Section B

REVIEWS

Shelter Compendium

B.4

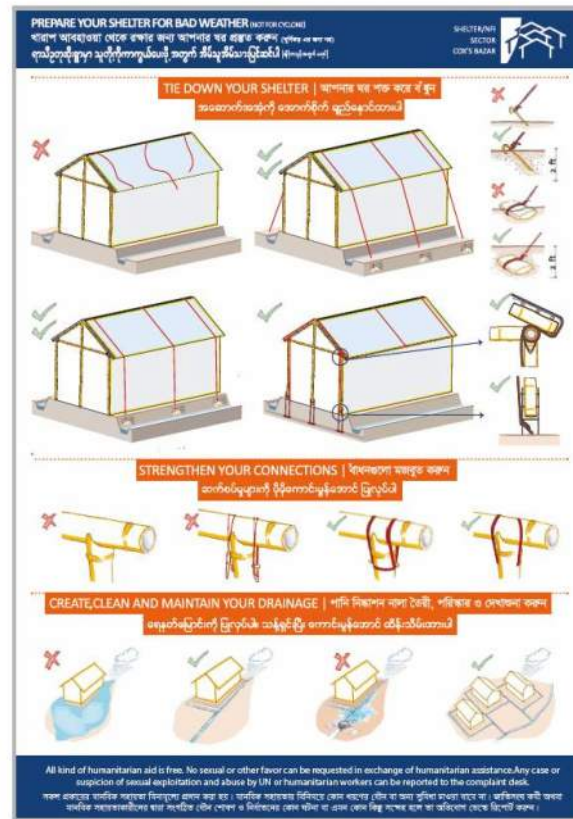
Technical Accuracy

"Messages are technically accurate."

"All the techniques were tested and assessed."

"Messages are accurate, however some parts are a bit generic. The message on drainage could be developed. It is vague to just suggest digging drainage. There are additional ways to reinforce this aspect such as larger roof overhang or temporary sandbags at the base, depending on the context. However, it is a large topic for limited space, and though generic, it can be well-received by its audience."

"More information should be provided on the materials used to hold the tie-down to the ground (brick, sandbag, etc.)"

"The message on PSEA is ok; however, it is unclear how beneficiaries can complain to said complaint desk."

"It mixes a lot of details which makes it a bit complex."

"Some of the details related to tying down are complex and very context specific."

"It is simple and a bit generic."

"The graphics are fine; however, it could be better organized to be clearer, and some details could be marked better to make it easier to understand."

"Imagery on tying down can be difficult to interpret. Needs an image on why tie-down is needed. Other imagery clear connections and drainage."

"Imagery for the second and third message is simple and intuitive, but the first message is confusing: it is not clear that the arrows will show the zoomed detail and the details themselves are also very hard to understand. It takes some time to catch the differences between the second and third way of fixing the ropes to the ground."

"The sandbag detail is small and needs a closer zoom. It is hard to determine where the sandbag is stuck, and other methods of fixing the rope that are pictured in the left corner, are related to."

"The fourth image that shows the foundation is complex and very small to see."

"Text is not needed to understand the imagery, it is mostly used to link the images to the messages that were distributed over radio."

"This material is based on assessment of weaknesses observed in construction in Cox's Bazar and the identified gaps."

"The first and the third part could be adapted to many places. The second part about the connections could be adapted to contexts that use bamboo, and probably mostly rural / peri-urban areas."

"Tie down using metal pegs or sandbags as well as strengthening connections and drainage can be easily reused in another context. Tying down to the footing is very specific to the context."

"No risk of being misunderstood. However, you can misunderstand the right and wrong if you look quickly at the two middle drawings in the 'strengthen your shelter' section."

"One of the difficulties when developing this IEC material was how to clearly present in 3D a tie down of a shelter, as there are several important structural elements that needed to be omitted from the image (bracing, wall cladding, wall structure)."

"It can include a picture of a shelter that was not properly prepared and got damaged."
